Design Review Board

777 THOMAS STREET | SEATTLE, WASHINGTON

MACFARLANE PARTNERS / ANKROM MOISAN ARCHITECTS, INC.
07.31.2013 DPD PROJECT # 3014045

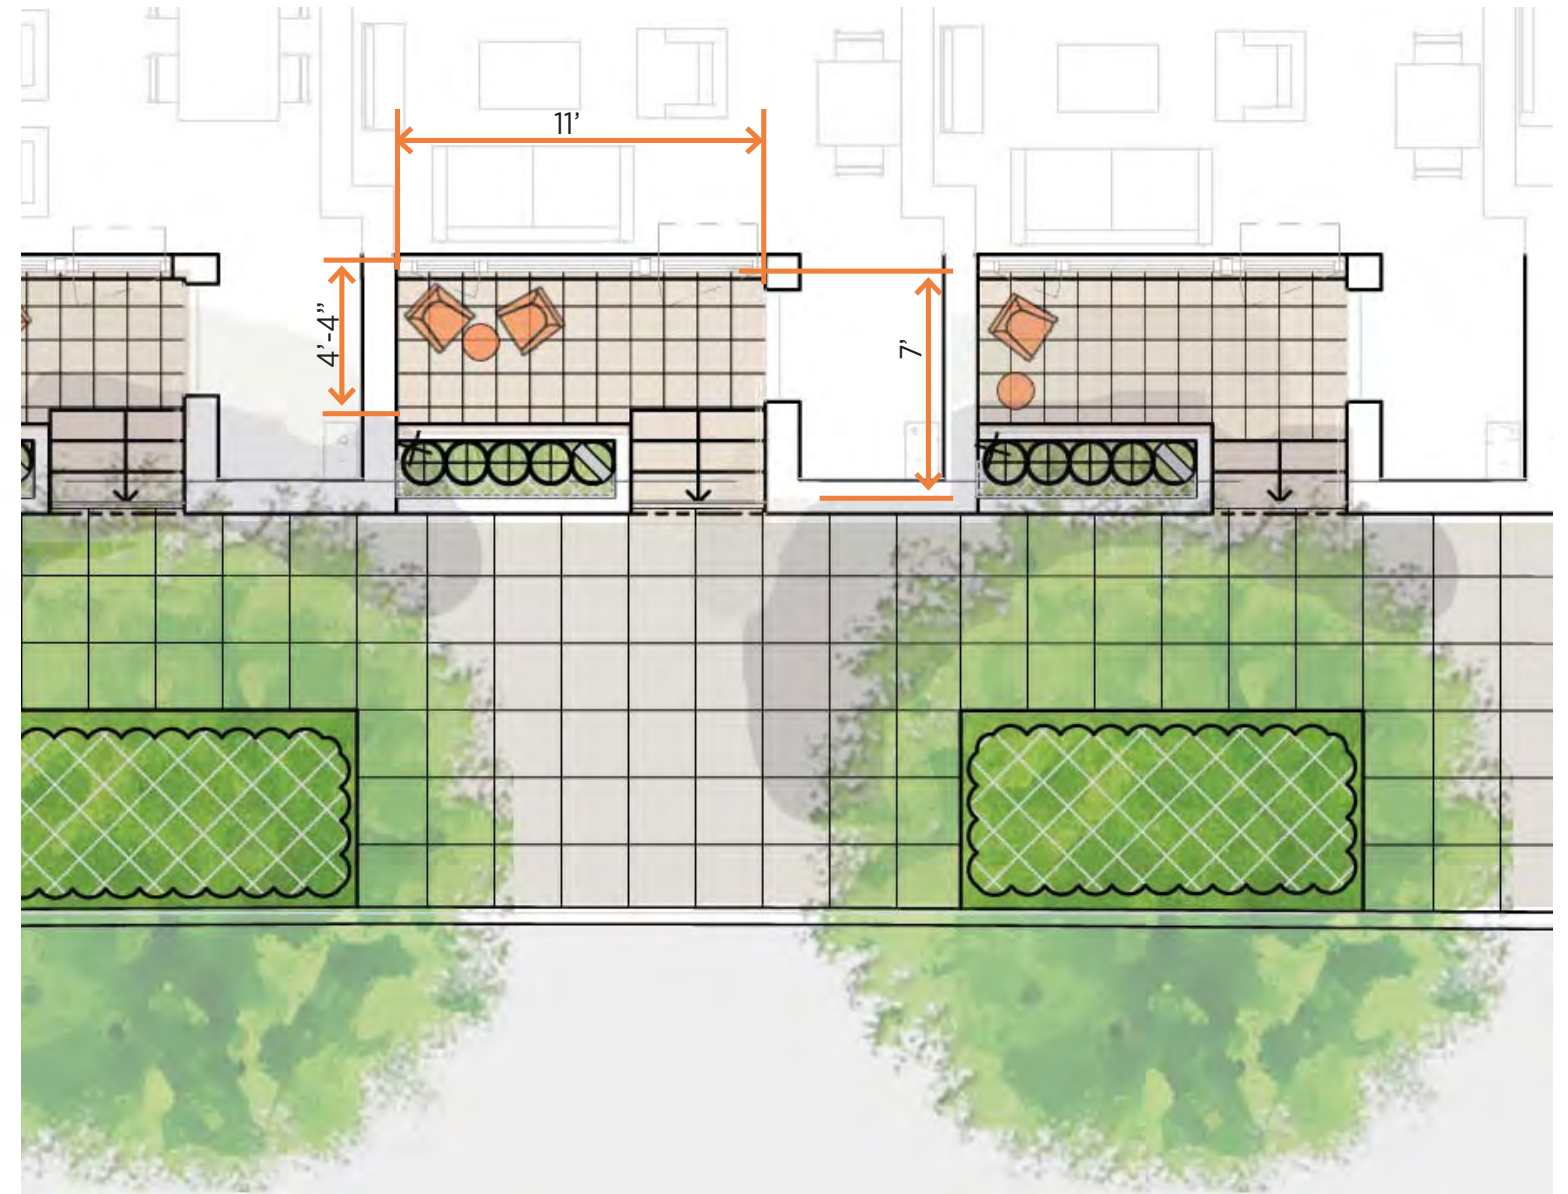
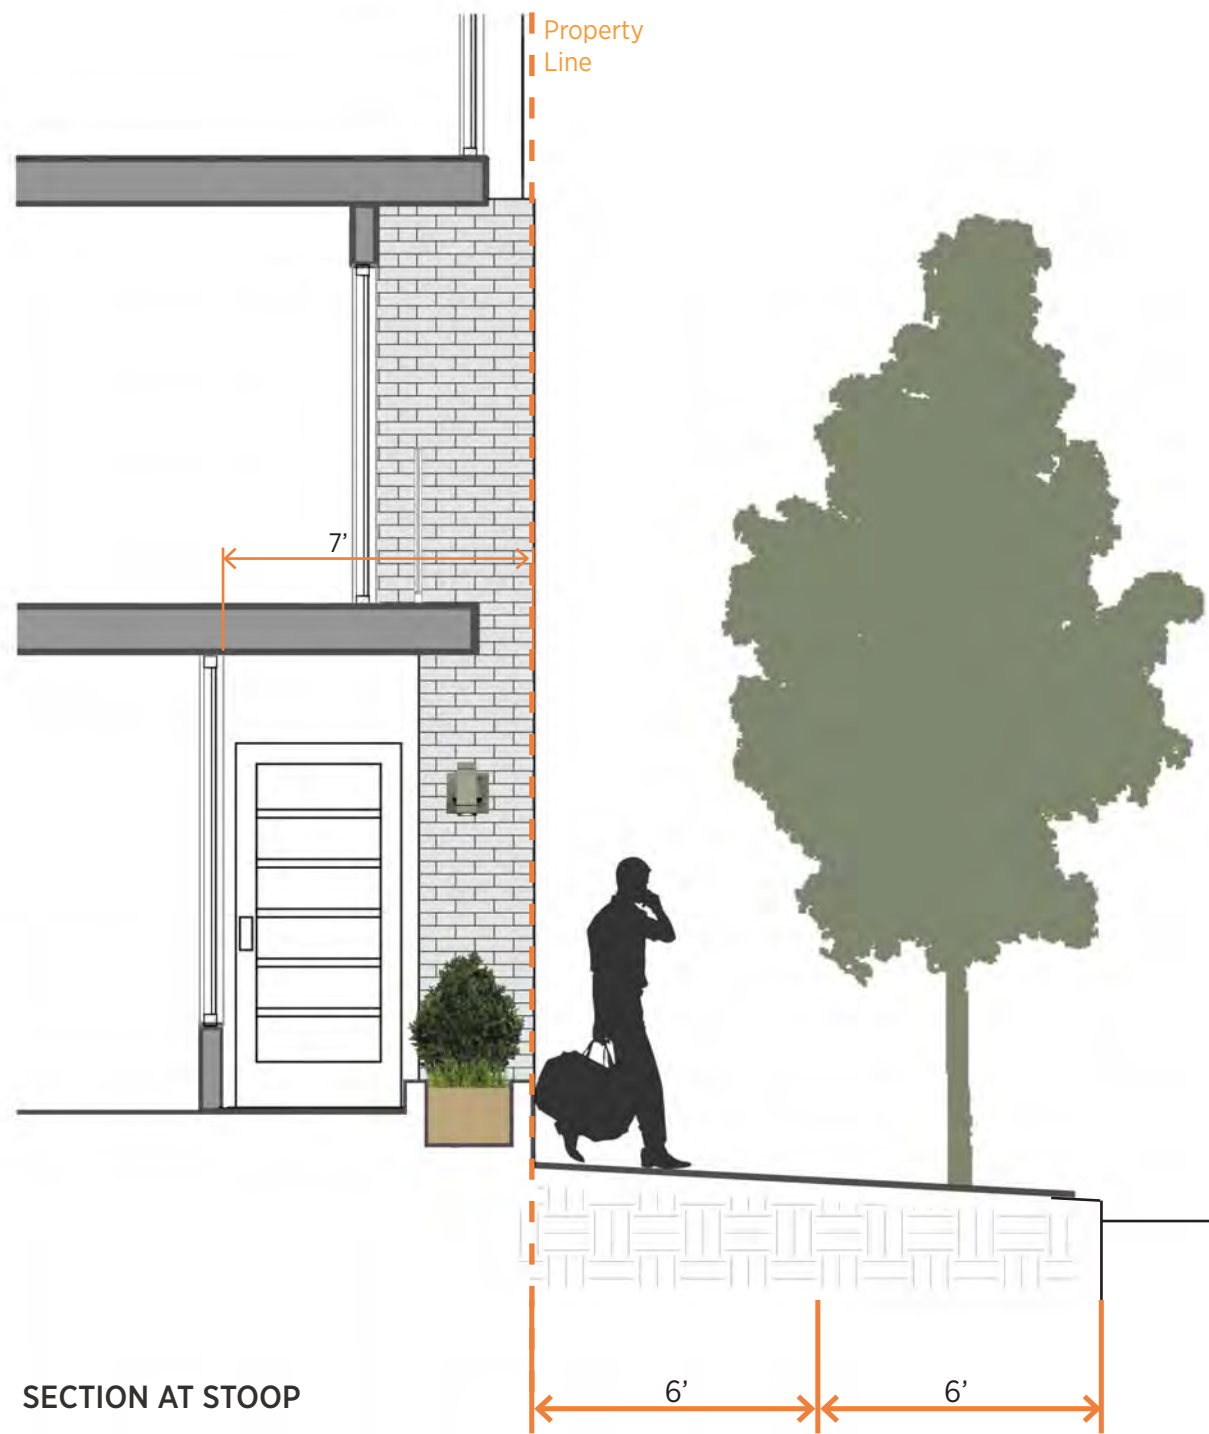
“... the planters separating the residential entries and the sidewalk should relate to a human scale and provide a visual transition to the entries.”

The Board reiterated the applicant should discuss options with SDOT to move the curb line further out to the street and provide a curb bulb.

The Board suggested that the planter walls be replaced with lower planters and taller landscaping to soften and screen the patios.

“The Board appreciated the orientation of the street level entries and felt that the design of the front patios would serve to enhance the entries and usability of the patios.”

ENLARGED ENTRY LANDSCAPE PLAN

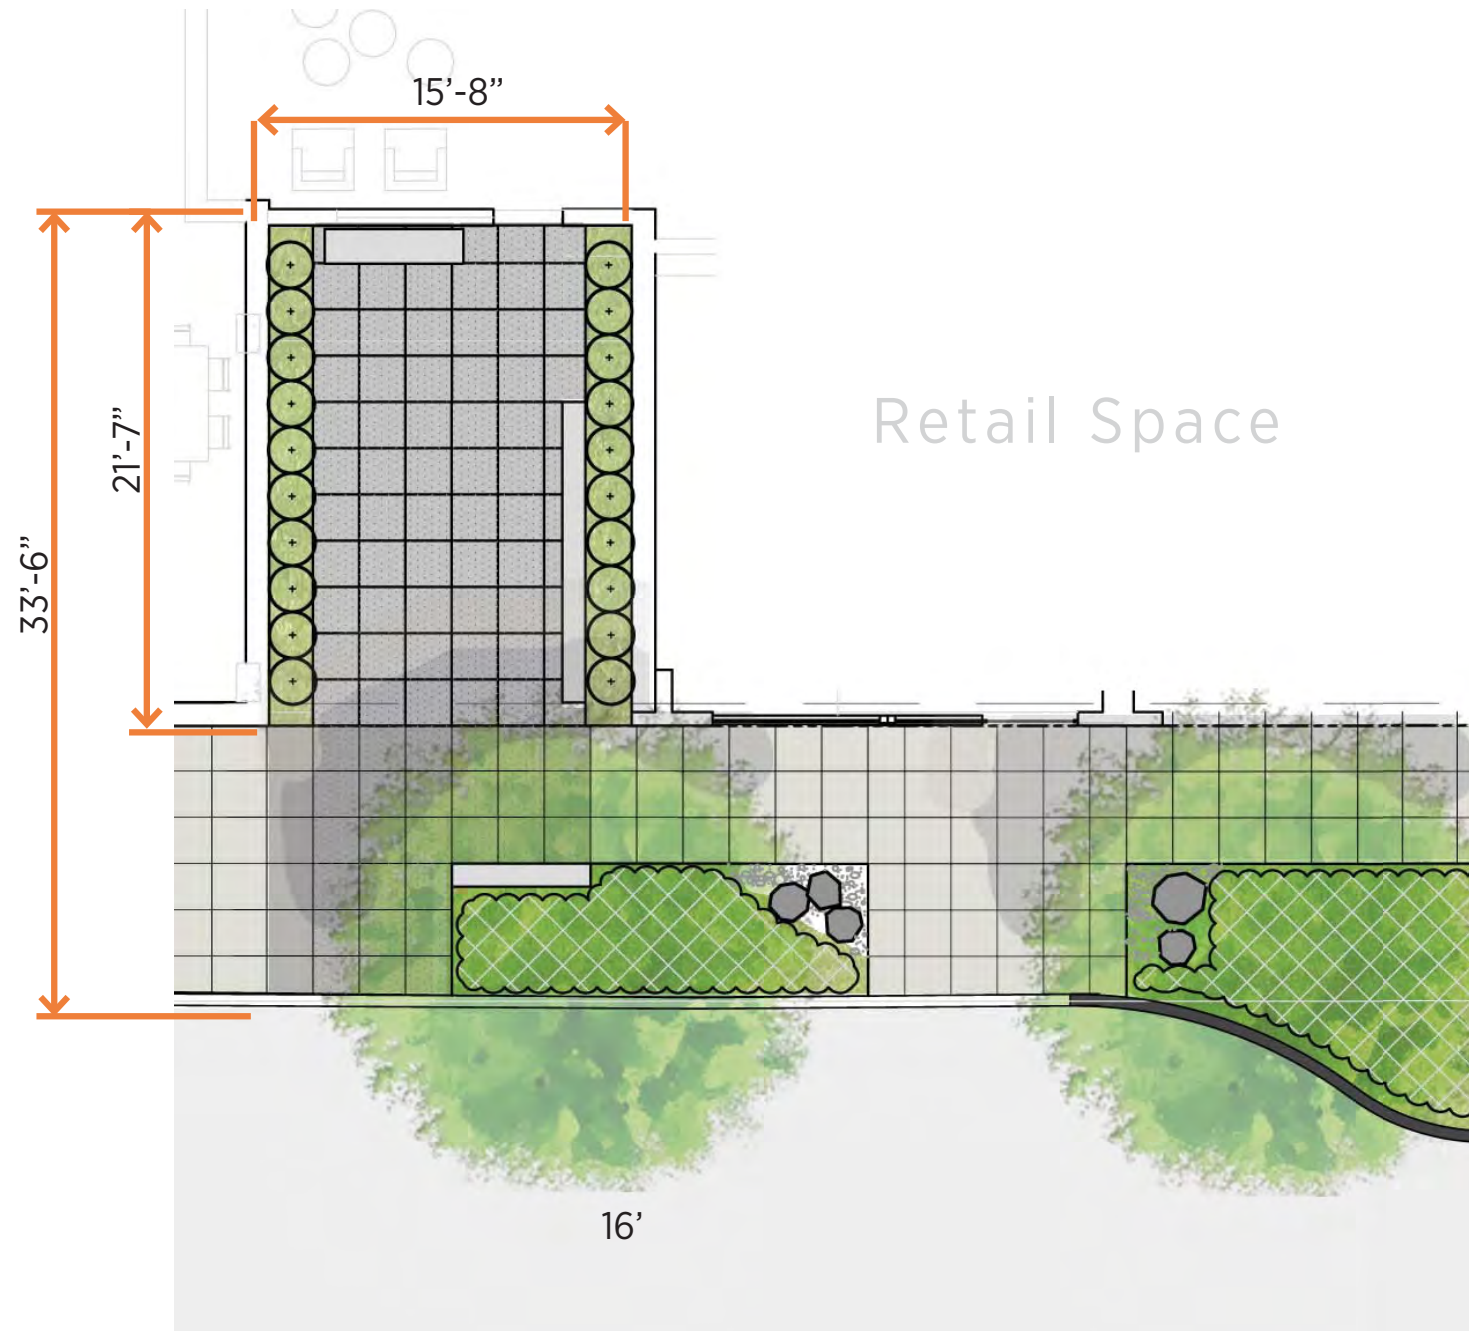
The Board noted that the area adjacent to the south facing wall of the historic landmark should be designed to enhance the recessed entry with items such as lighting, landscaping, and benches.

The Board recommended that the ROW should include items to delineate the entry location, such as benches or landscaping

1. LANDSCAPE FORMS PARALLEL BENCH

2. LOW ACCENT WALLS.

3. PET REST AREA IN PLANTERS.

4. PLANTINGS AT FOUNDATION AND CANOPY.

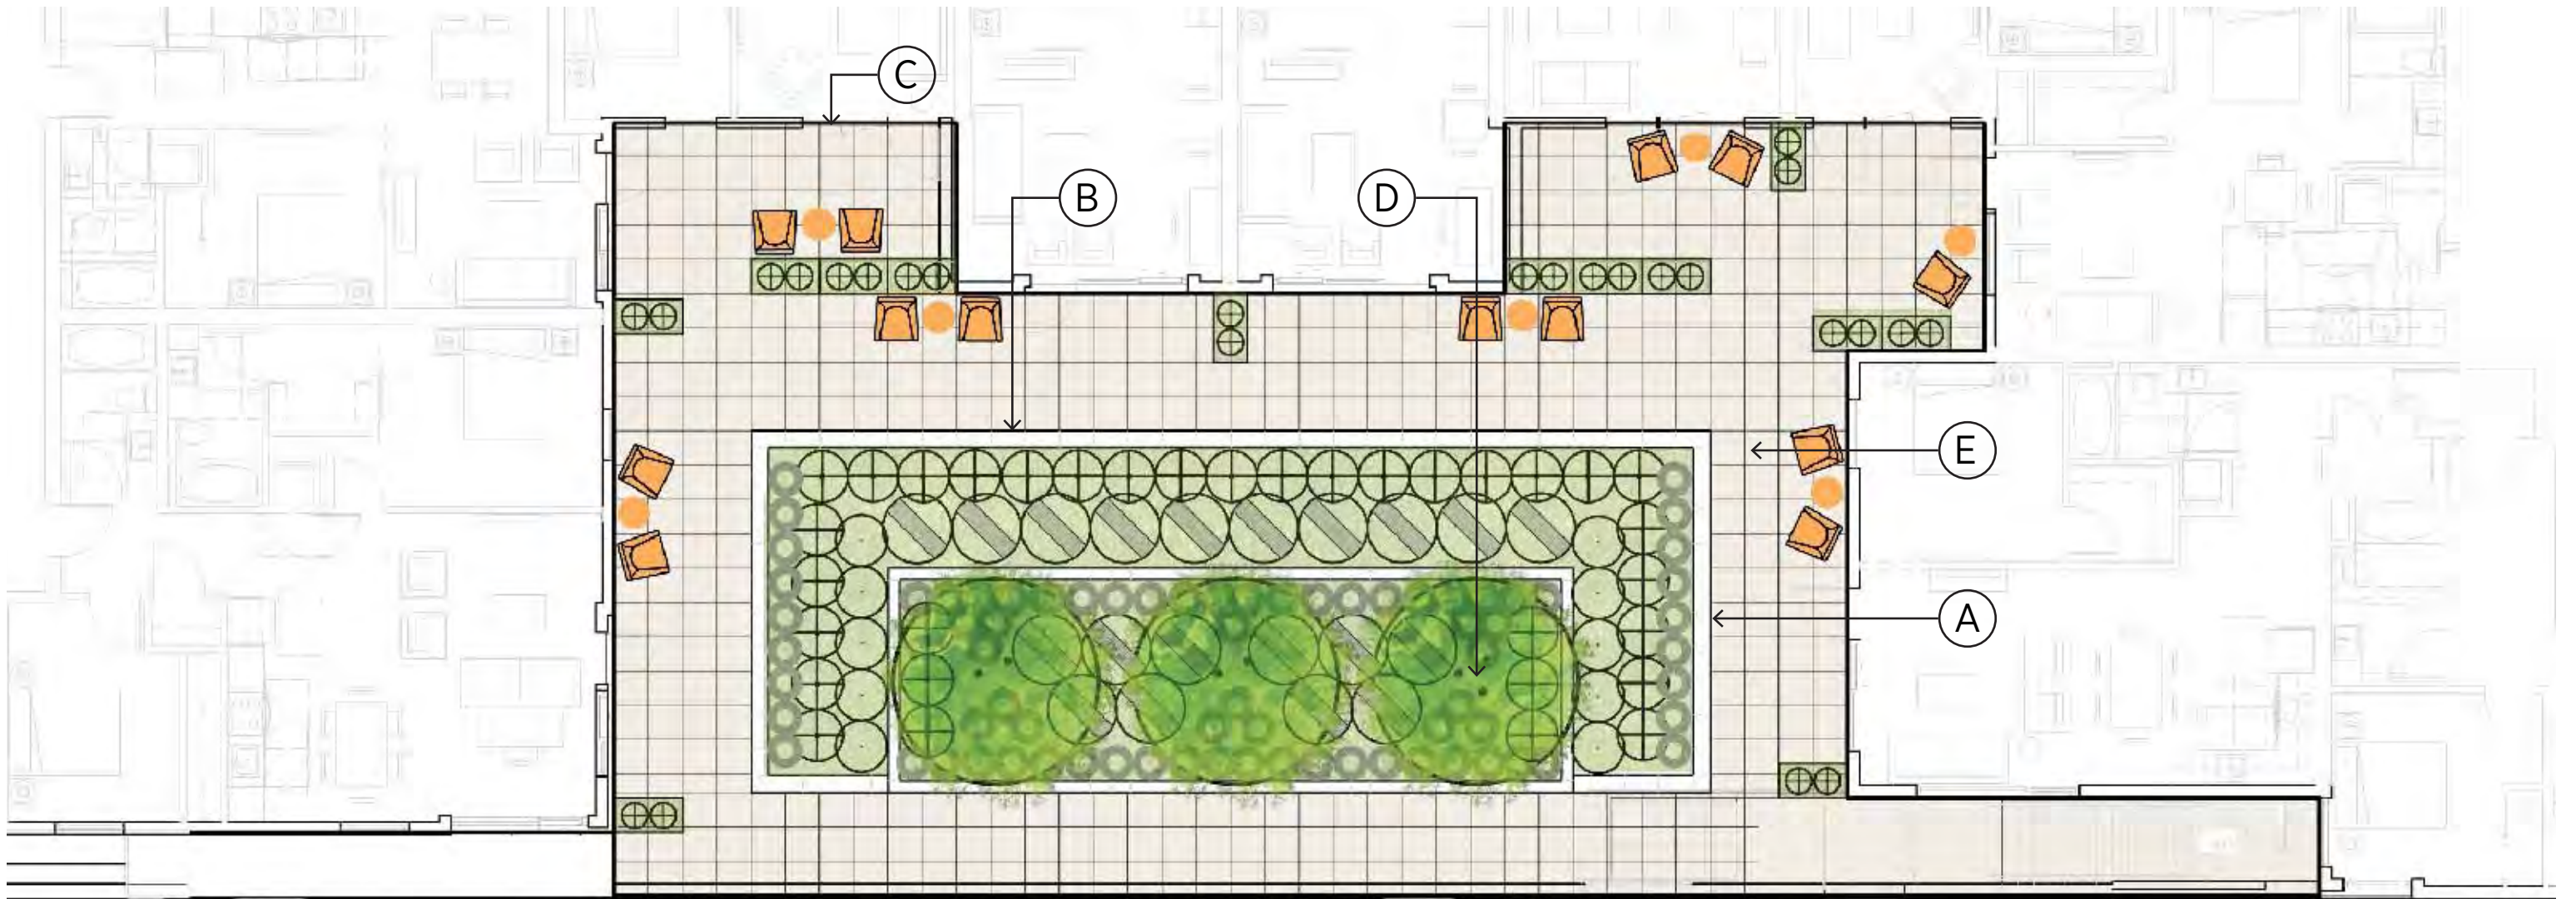
“The Board was concerned with the safety issues presented by the recessed garage entry.”

“The applicant should demonstrate how the staging area will sufficiently accommodate the collection schedule and amount of solid waste on collection days.”

The Board noted that locating the garage door entry should line up with the wall of the building above.
